## Addendum No. 6

Austin Masjid  
800 N Heatherwilde Blvd., Pflugerville, TX 78660  
June 19, 2026

Project Number: 2305

**P4.02**

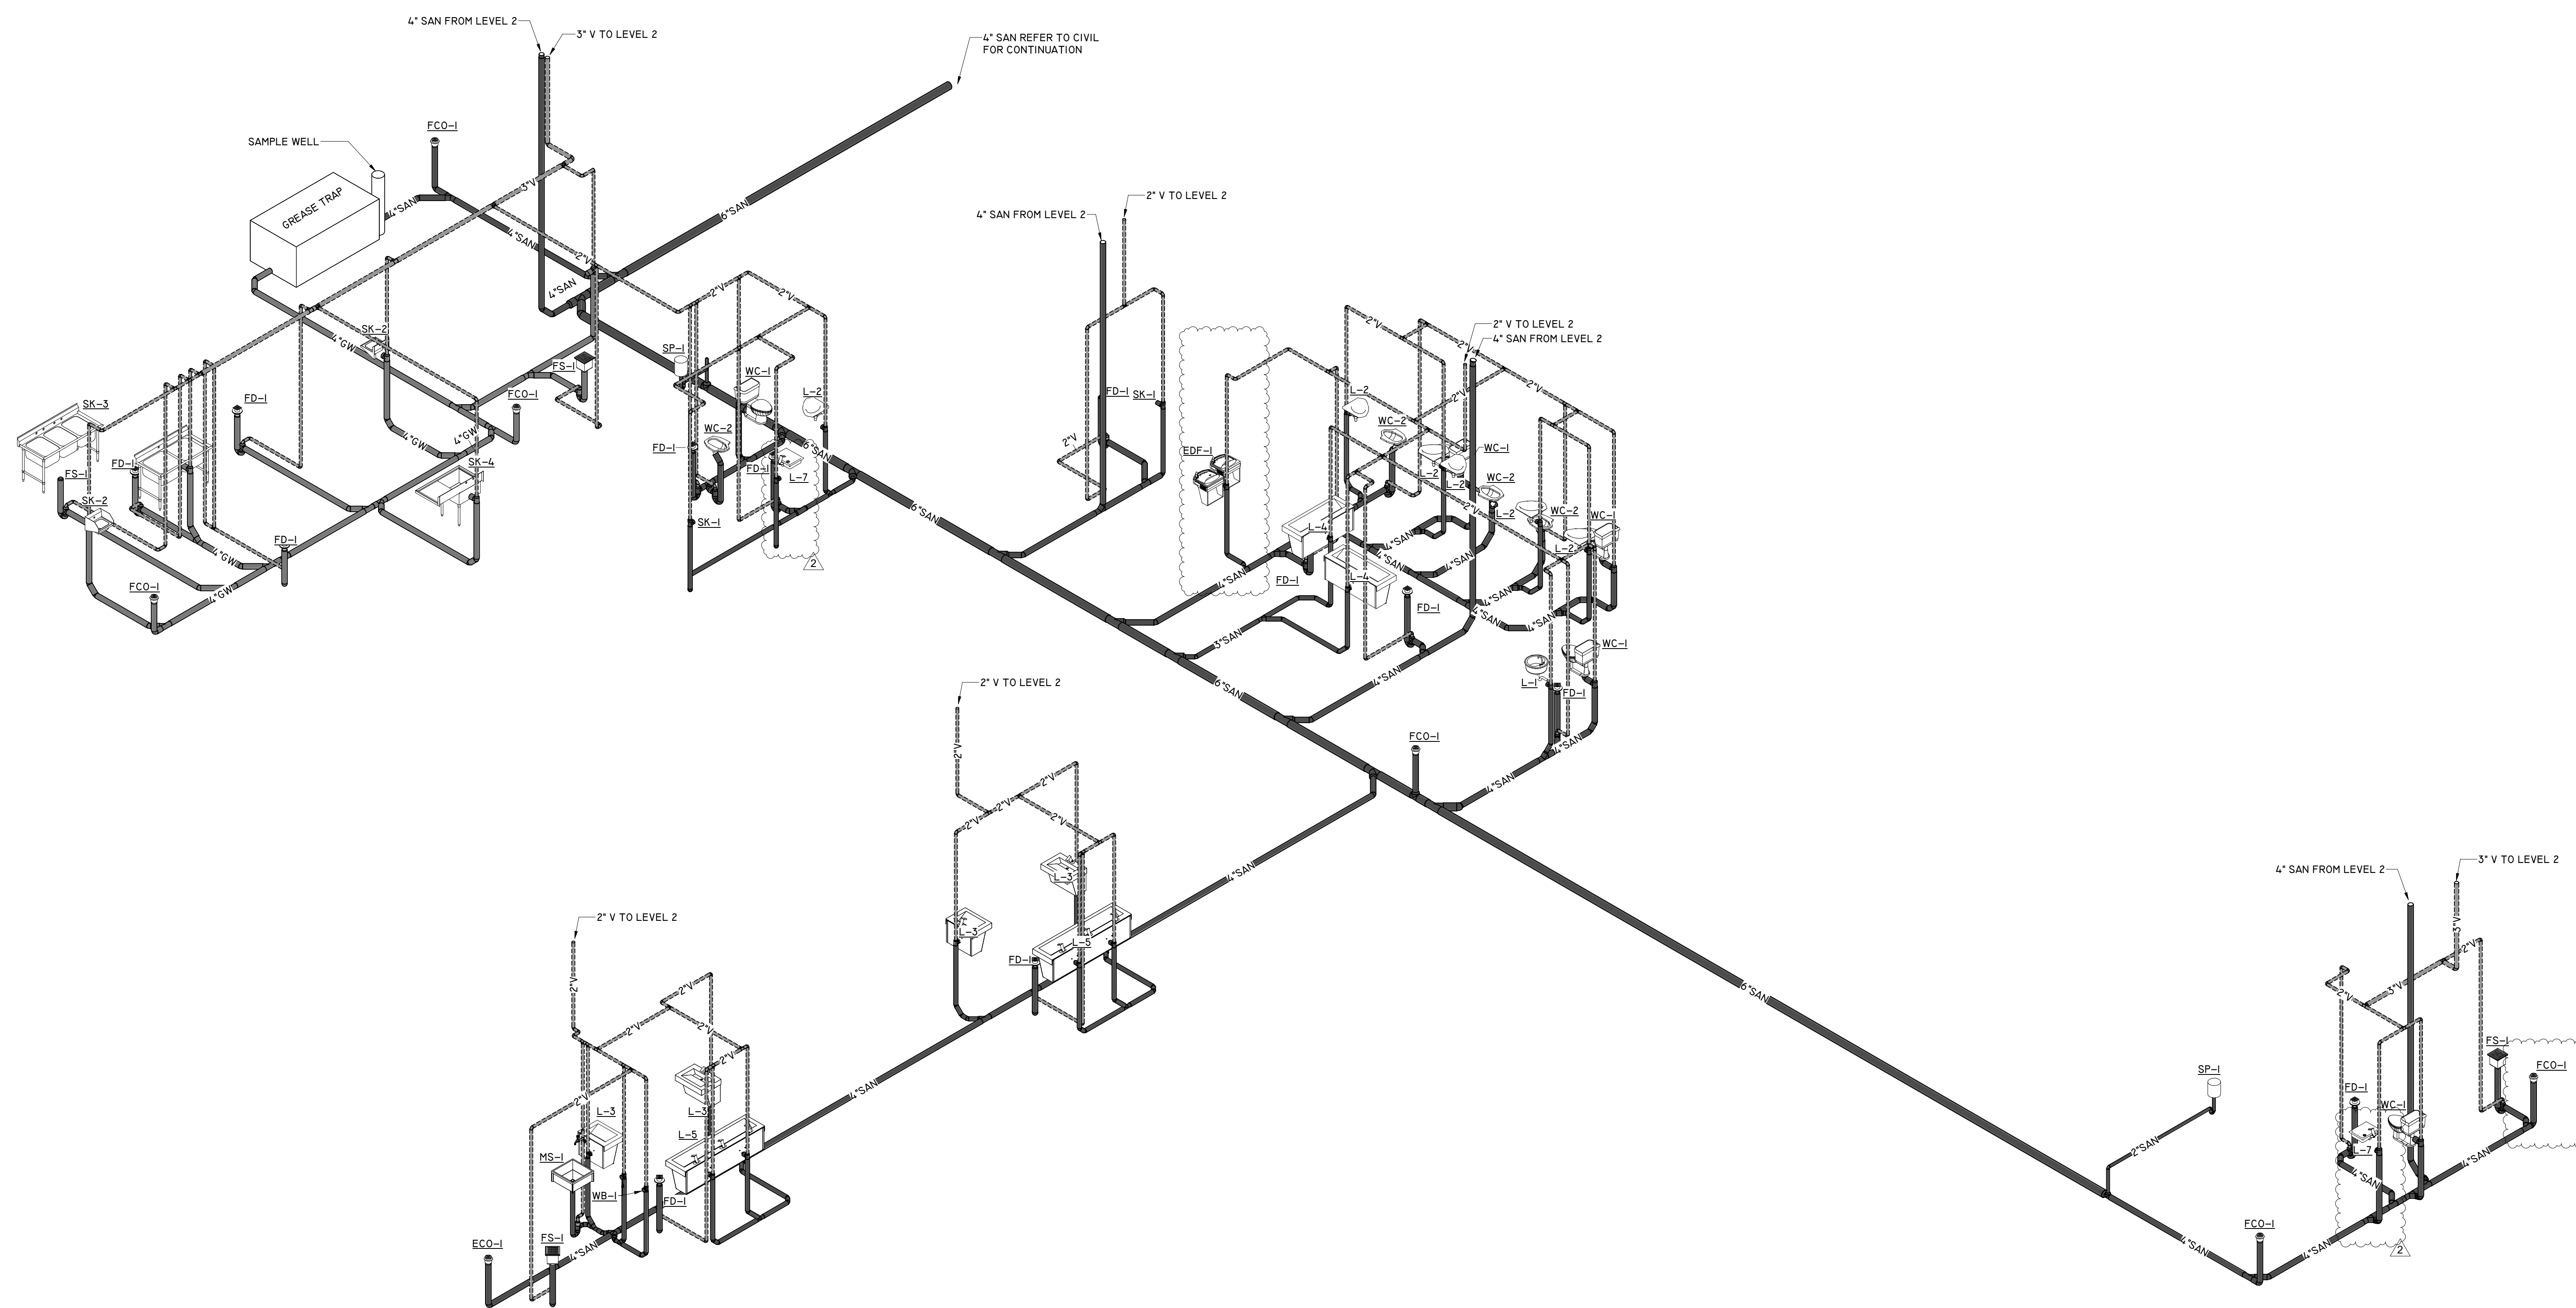
P4.02 ADJUSTED TO MATCH FLOOR PLAN. ADJUSTED TAGS

**P4.03**

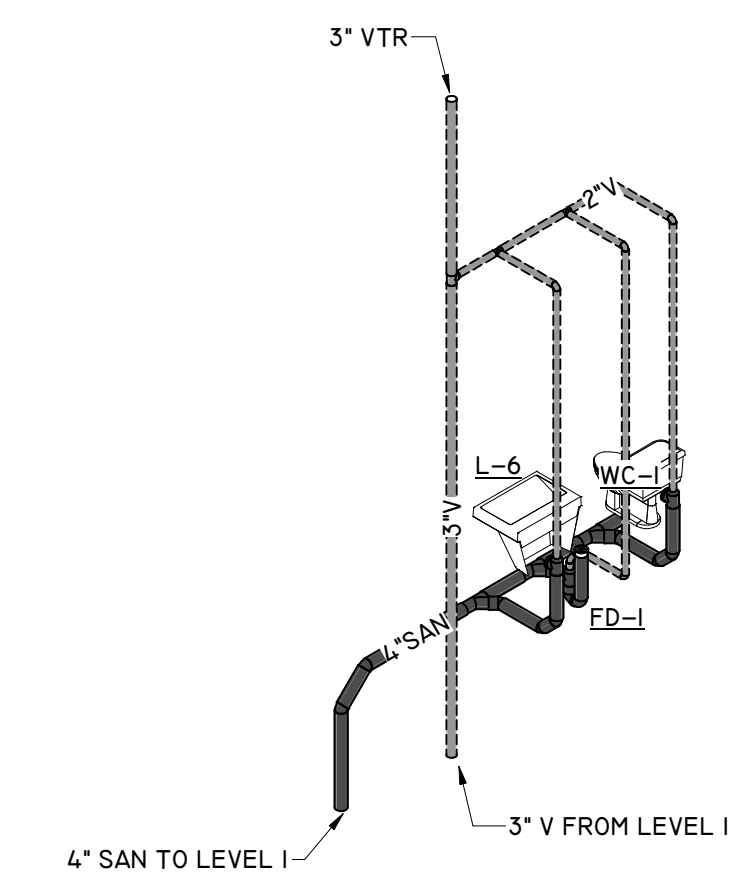
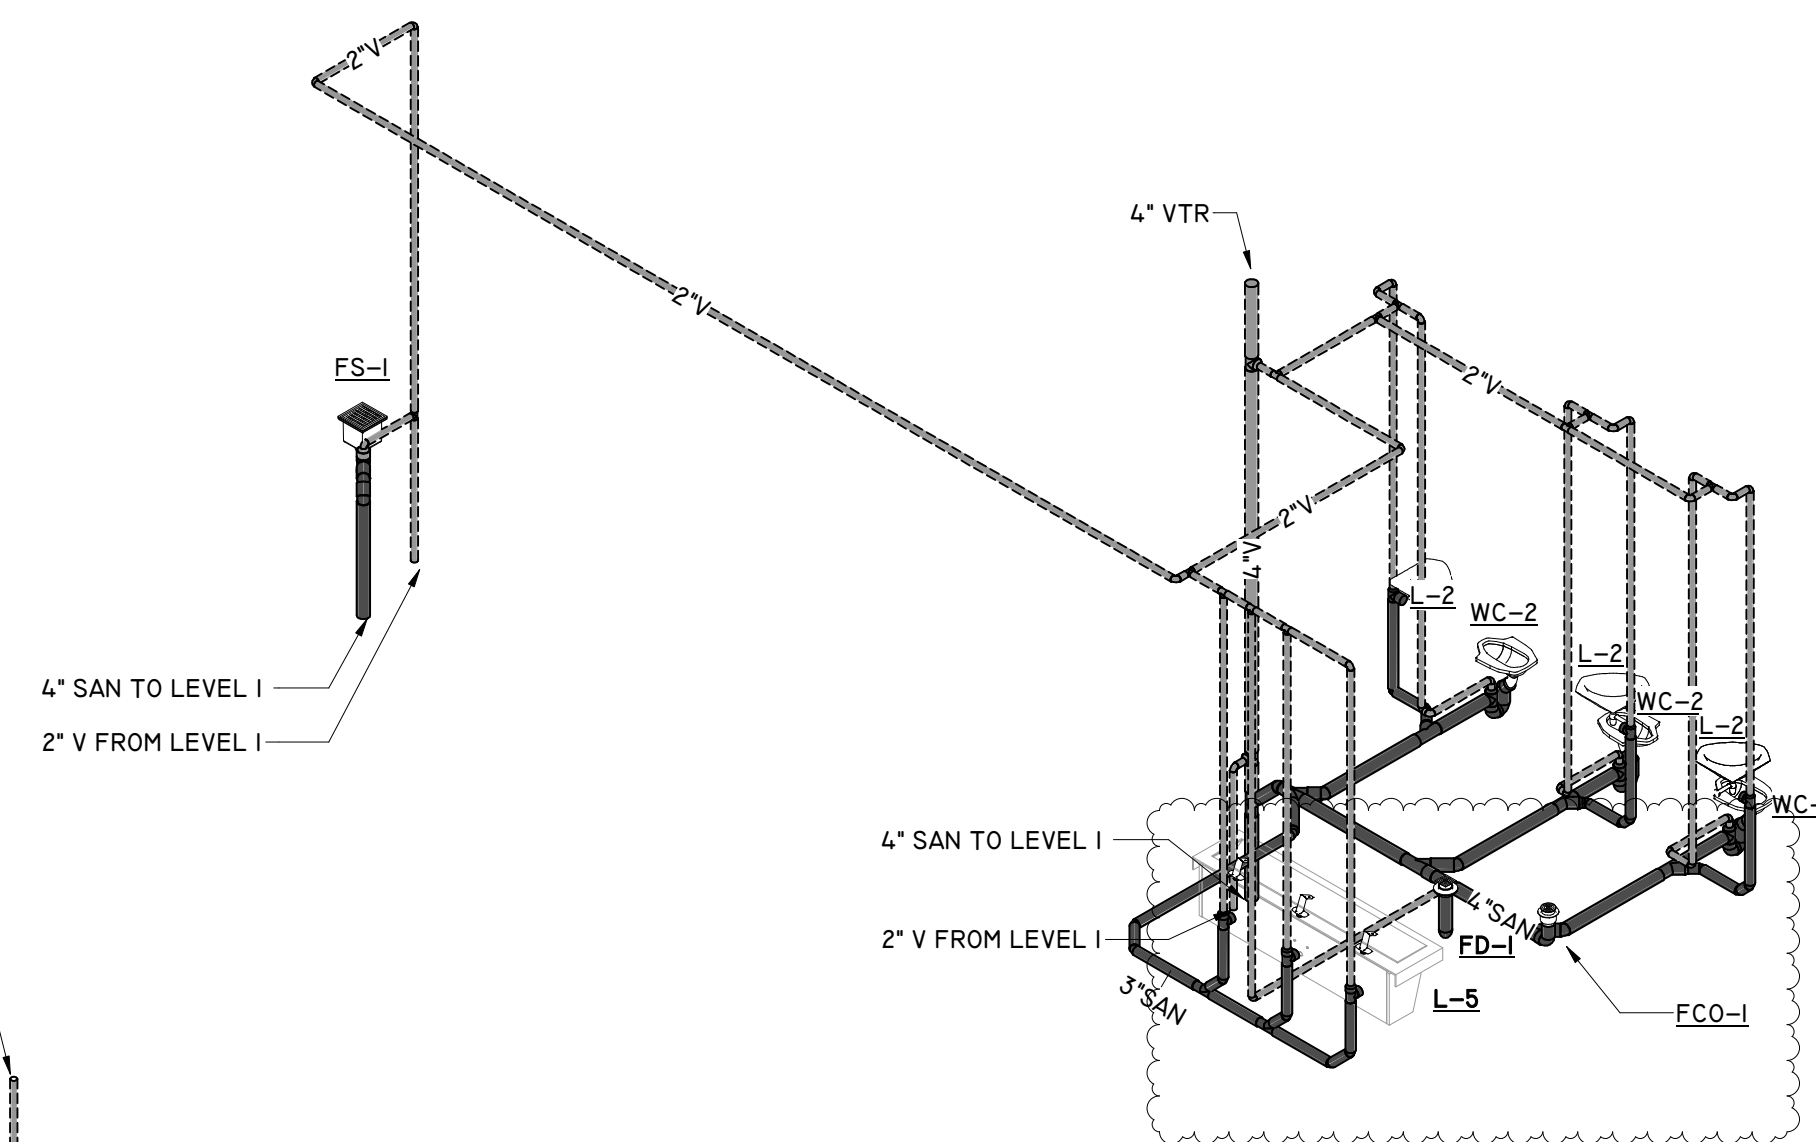
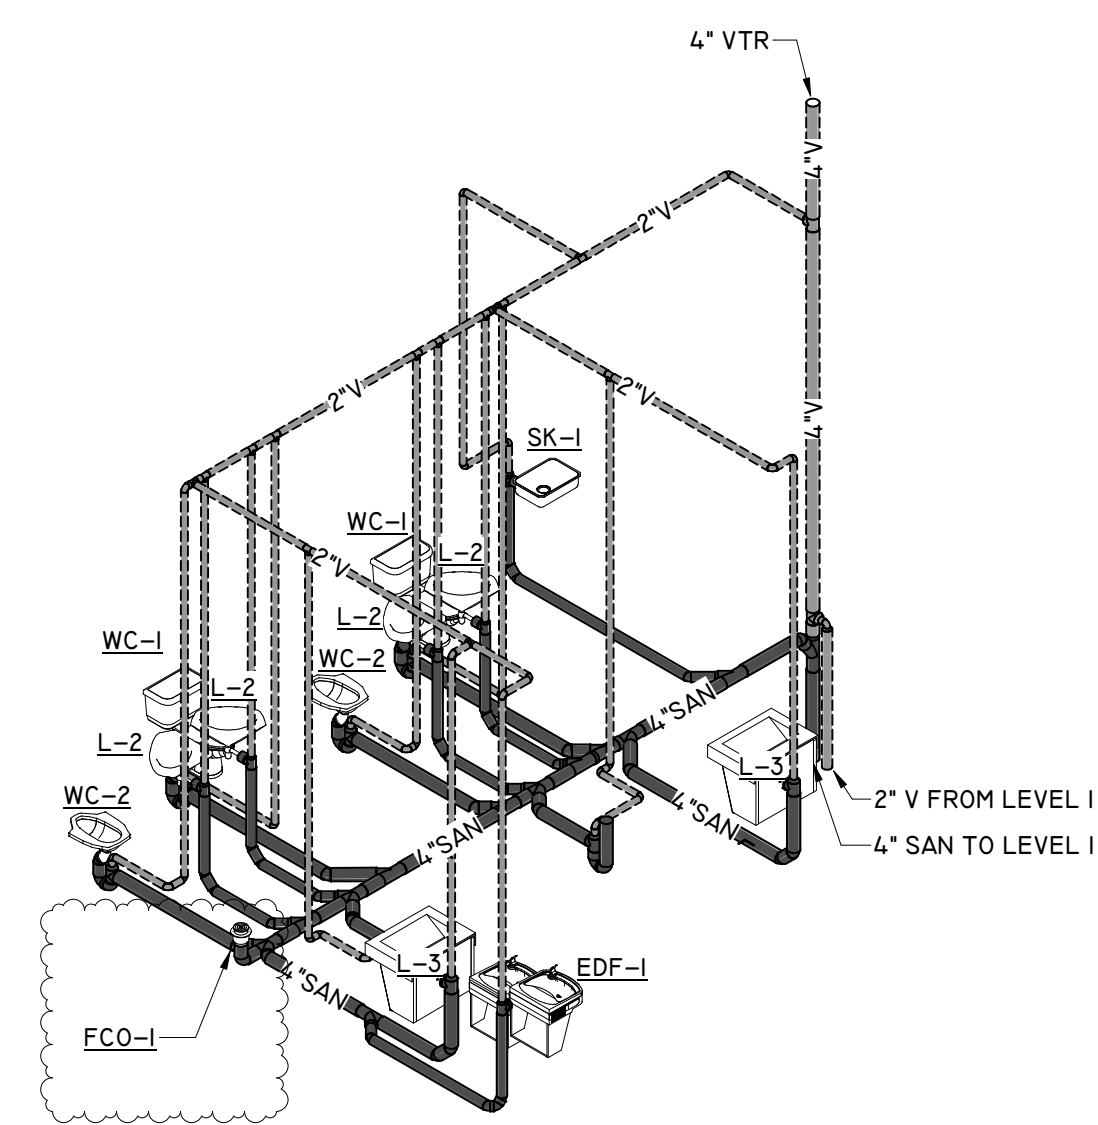
P4.03 ADJUSTED TO MATCH FLOOR PLAN. ADJUSTED TAGS
